ADDENDUM NO. 2

**PROJECT NO. ES 2022-10 CITYWIDE LIFT STATION
IMPROVEMENTS TURLEY NORTH LIFT STATION**

**PROJECT NO. TMUA ES 2022-10
CITYWIDE LIFT STATION IMPROVEMENTS
TURLEY NORTH LIFT STATION**

TURLEY NORTH LS DEMOLITION PLAN
TMUA PROJECT NUMBER ES 2022-10
CITYWIDE LIFT STATION IMPROVEMENTS
CITY OF TULSA, OKLAHOMA
WATER AND SEWER DEPARTMENT

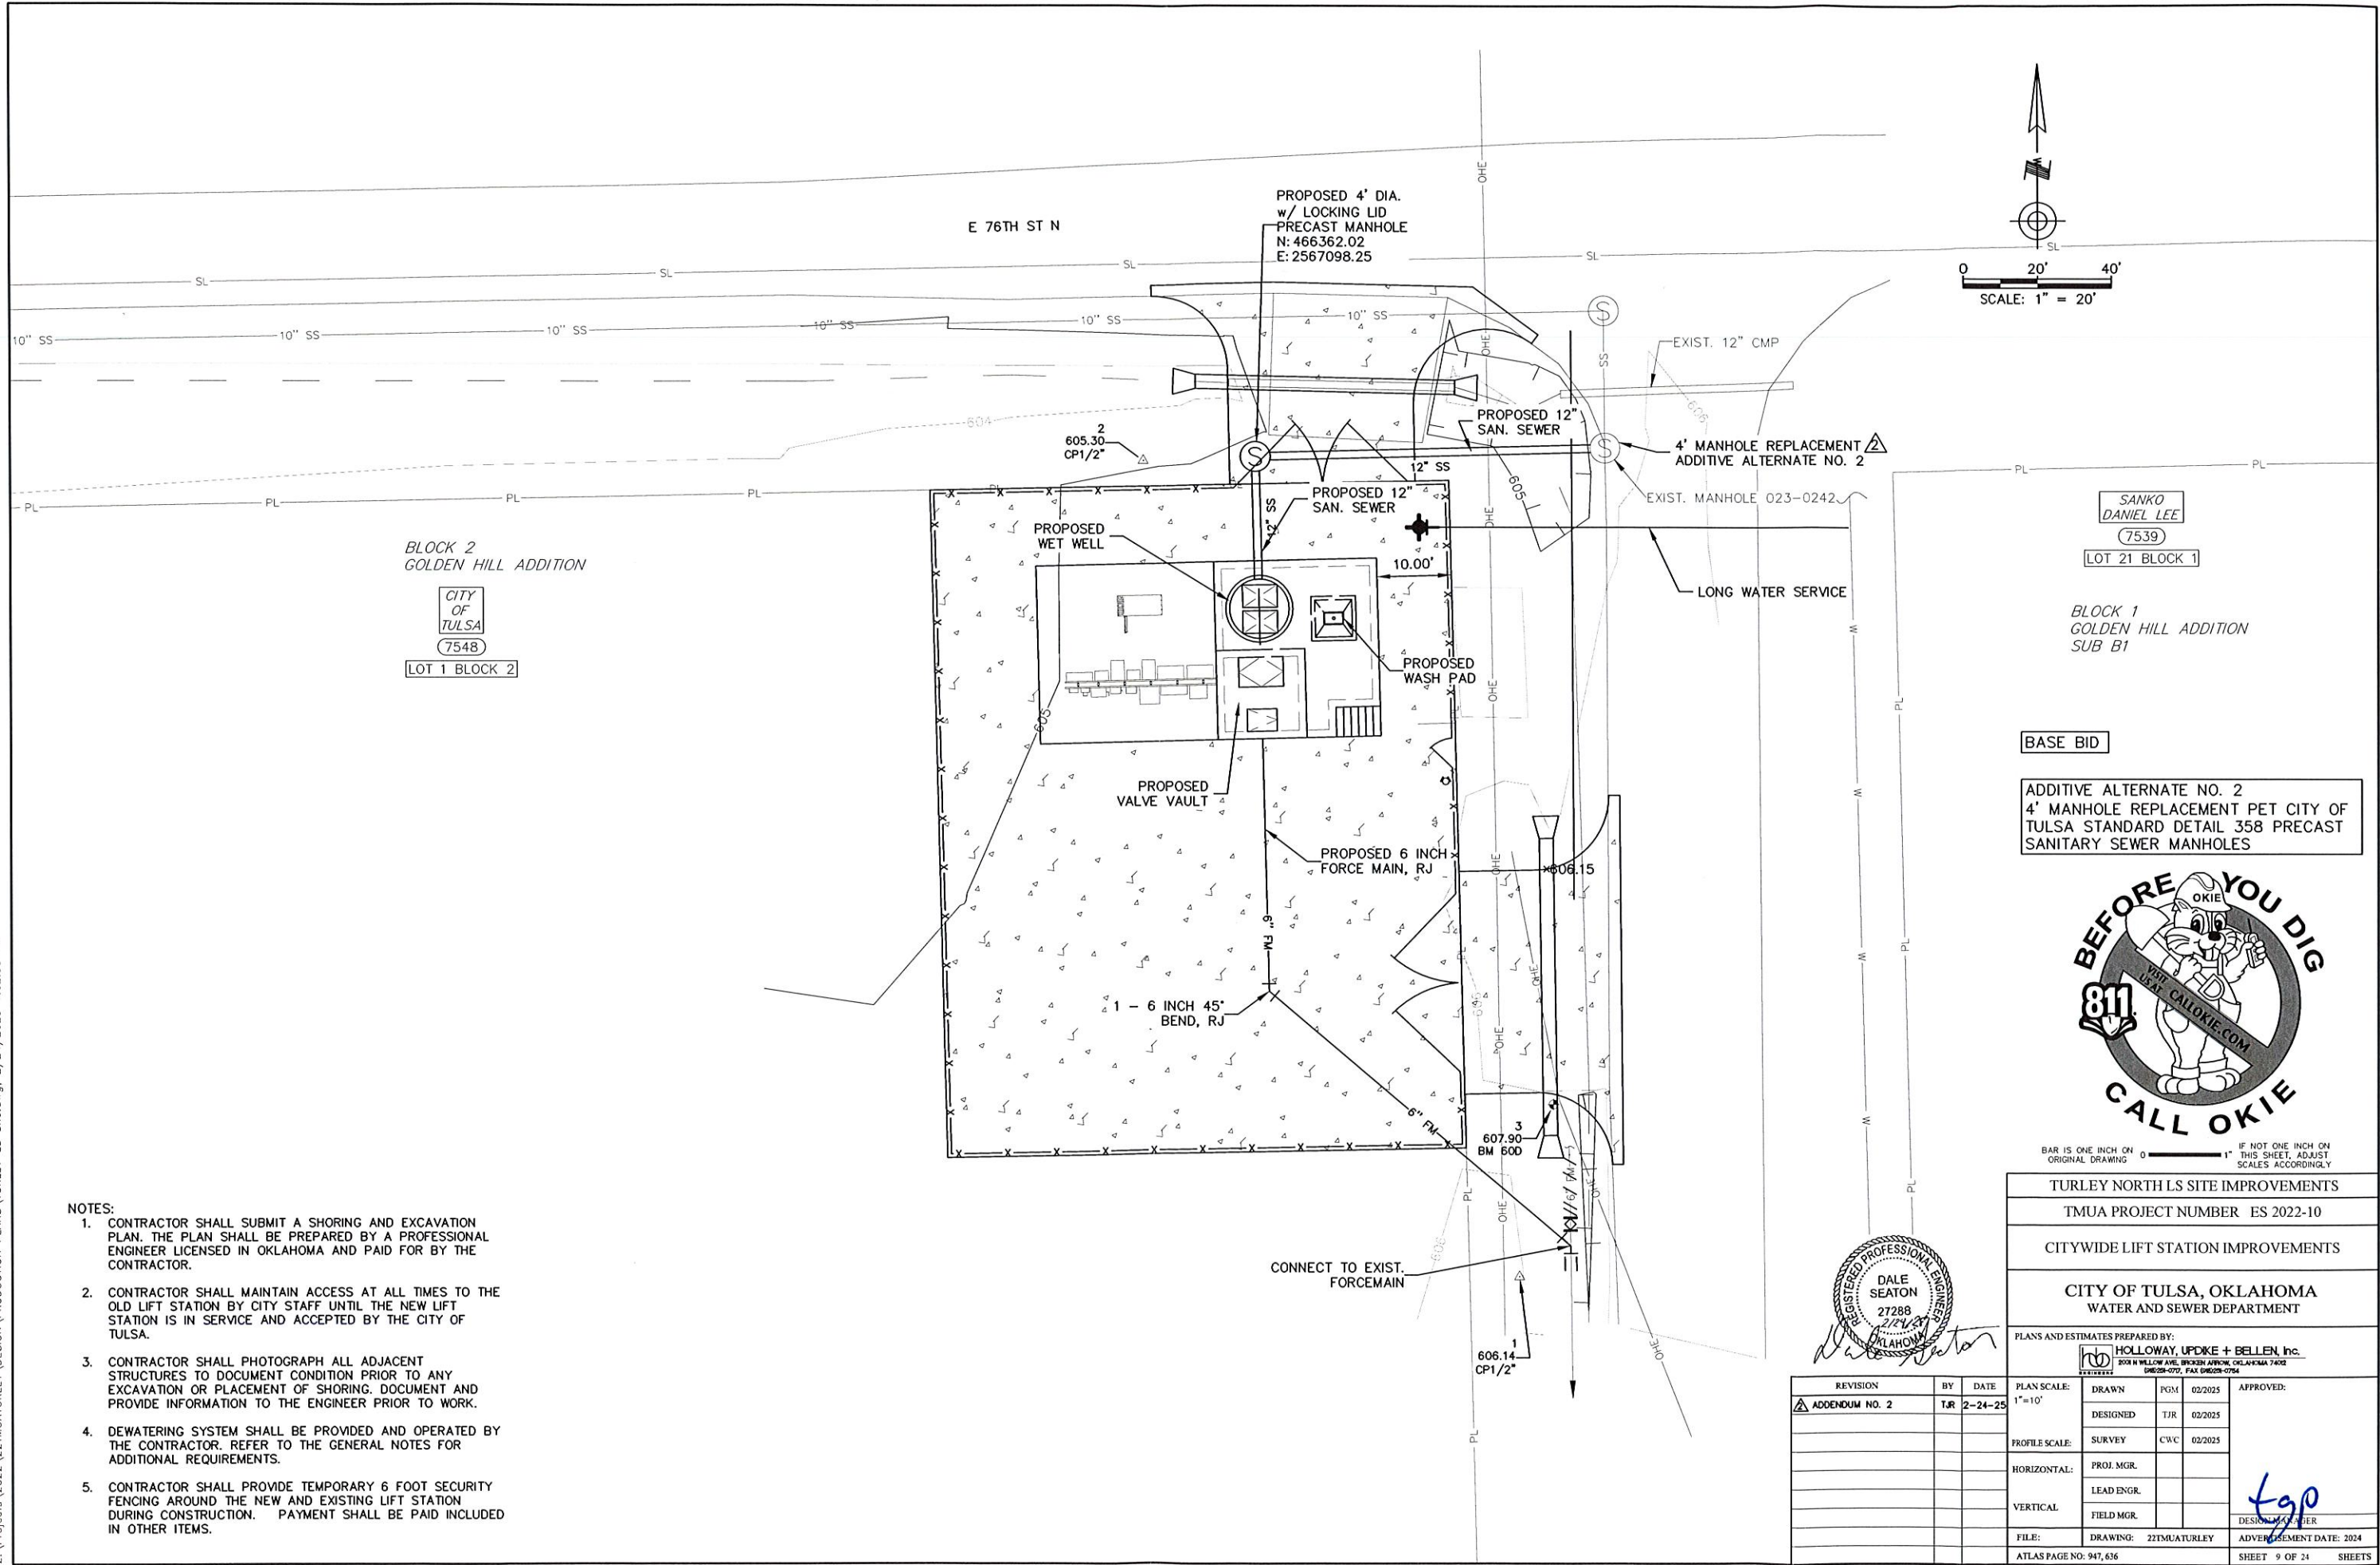
5. Question: The existing manhole 023-0242 is a brick manhole (see attached image). Since this project requires tying into this manhole, does the City of Tulsa want it replaced?
 - o If the City prefers to retain the manhole, will an epoxy coating be required?

Answer: See ADDENDUM NO. 2. ADDITIVE ALTERNATE NO. 2 has been added for the replacement of said manhole and all corresponding work associated.

ADDITIVE ALTERNATE NO. 2
4' MANHOLE REPLACEMENT PET CITY OF TULSA STANDARD DETAIL 358 PRECAST SANITARY SEWER MANHOLES

TURLEY NORTH LS PLAN & PROFILE
TMUA PROJECT NUMBER ES 2022-10
CITYWIDE LIFT STATION IMPROVEMENTS
CITY OF TULSA, OKLAHOMA
WATER AND SEWER DEPARTMENT

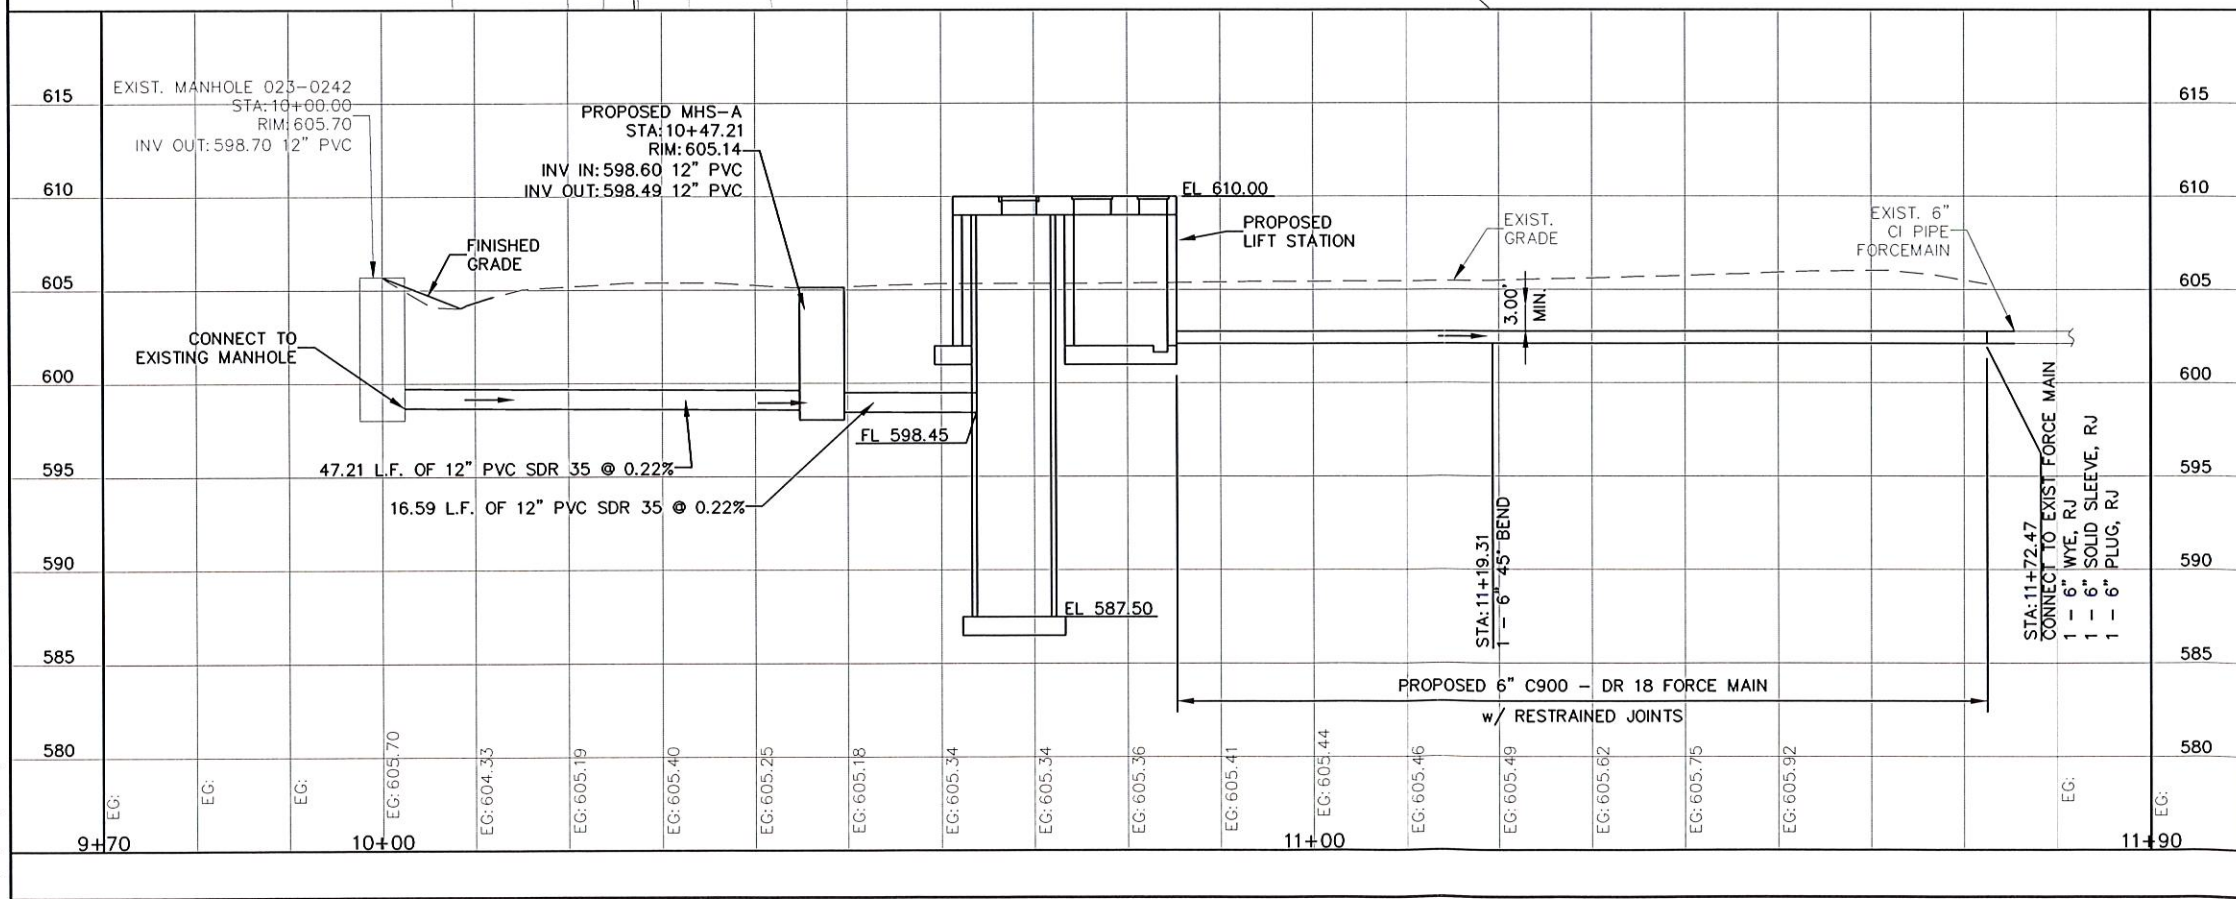
6. If the City opts to replace the manhole with a precast structure, would the contractor need to create a penetration to keep the existing lift station operational? Or would penetrations only be required for tying in the existing 8” and 10” lines along with the proposed 12” influent?
 - o **Note:** Sheet 11, Note 1.B states that the existing lift station must be isolated for 14 days to ensure trouble-free operation of the new lift station. However, the contractor would be able to bypass from proposed manhole MHS-A to the existing wet well if an issue arises during this 14-day period.

Answer: See ADDENDUM NO. 2. ADDITIVE ALTERNATE NO. 2 has been added for the replacement of said manhole and all corresponding work associated. Contractor shall provide stand-by, bypass pumping in lieu of keeping the old station online.

- ADDITIVE ALTERNATE NO. 2: IF AWARDED, NEW MANHOLE WILL NOT CONNECT TO EXISTING STATION. CONTRACTOR SHALL PROVIDE STAND-BY, BYPASS PUMPING UNTIL NEW STATION OPERATES FOR 14 CONTINUOUS, TROUBLE-FREE DAYS.

TURLEY NORTH LIFT STATION SECTIONS
 TMUA PROJECT NUMBER ES 2022-10
 CITYWIDE LIFT STATION IMPROVEMENTS
 CITY OF TULSA, OKLAHOMA
 WATER AND SEWER DEPARTMENT

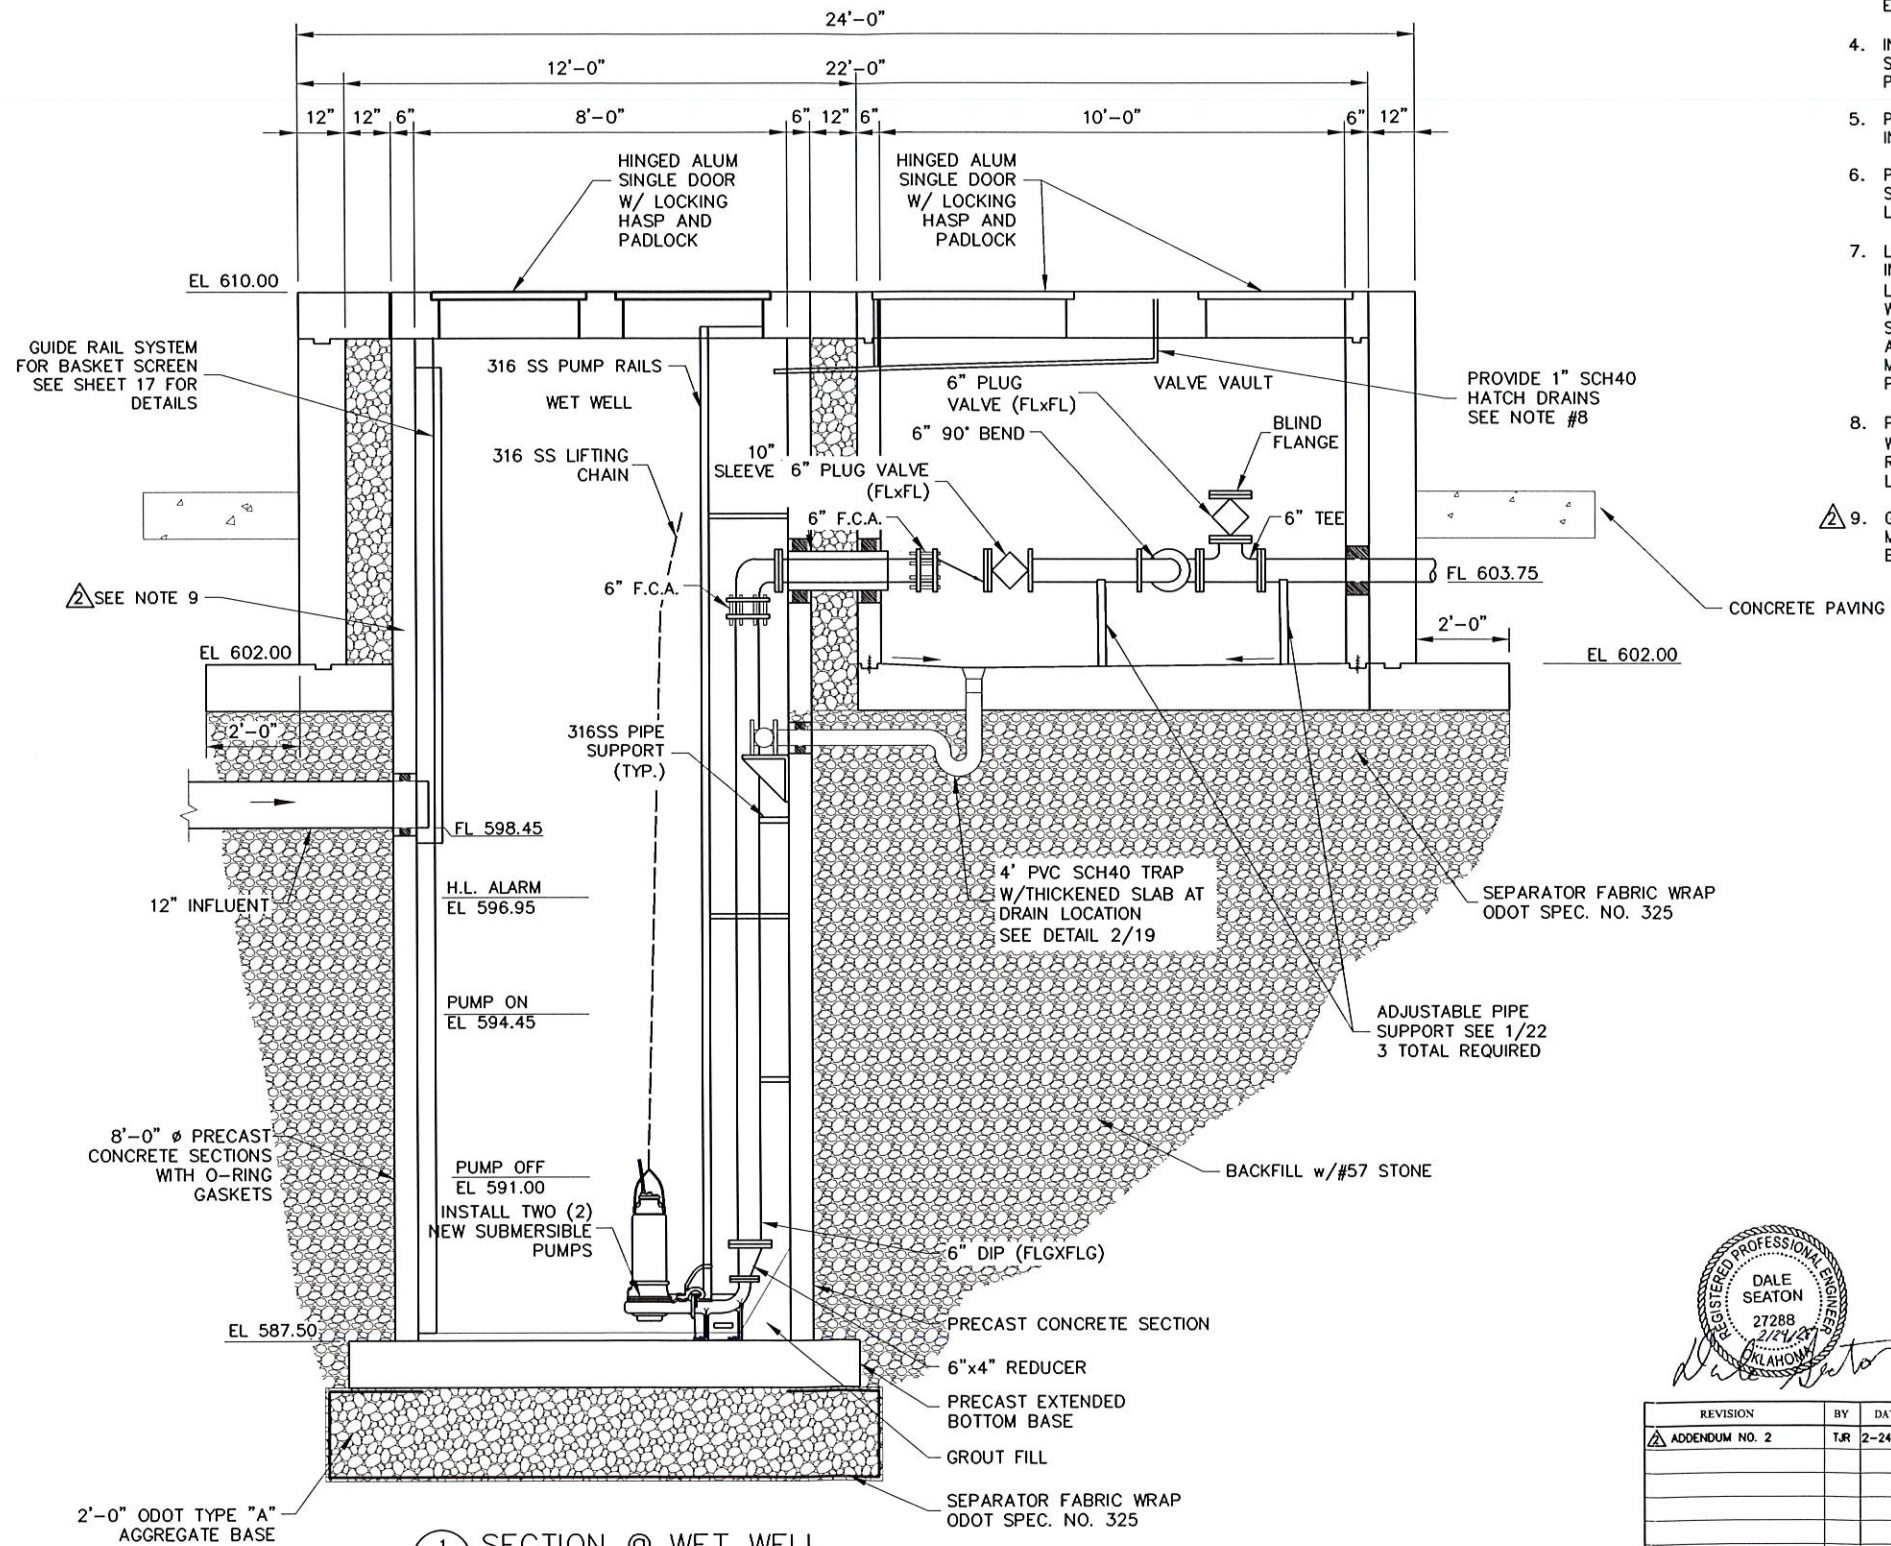
13. Question: The proposed basket screen being square in shape will not work with the proposed round manhole wall. Can you please advise if a modification to the basket screen is to be made or if the vault should be adjusted to be a square vault.

Answer: See ADDENDUM NO. 2. Contractor shall grout fill and lag bolt guide rail system to manhole wall to provide flush surface for basket screen.

9. GROUT FILL AND LAG BOLT GUIDE RAIL SYSTEM TO MANHOLE WALL TO PROVIDE FLUSH SURFACE FOR BASKET SCREEN.

1 TYPICAL SECTION - PAVING
20 SCALE: 1/2" = 1'-0"

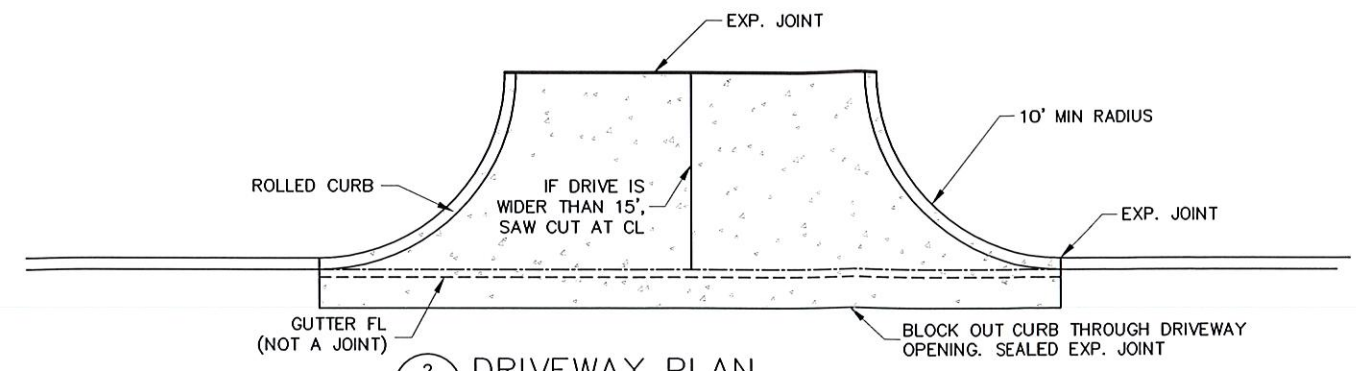
7. Question: Sheet 20 Detail 1/20 is calling for Tack Coat under the proposed concrete paving. Is this note correct or is this note to be removed?

Answer: See ADDENDUM NO. 2. Note for Tack Coat has been removed.
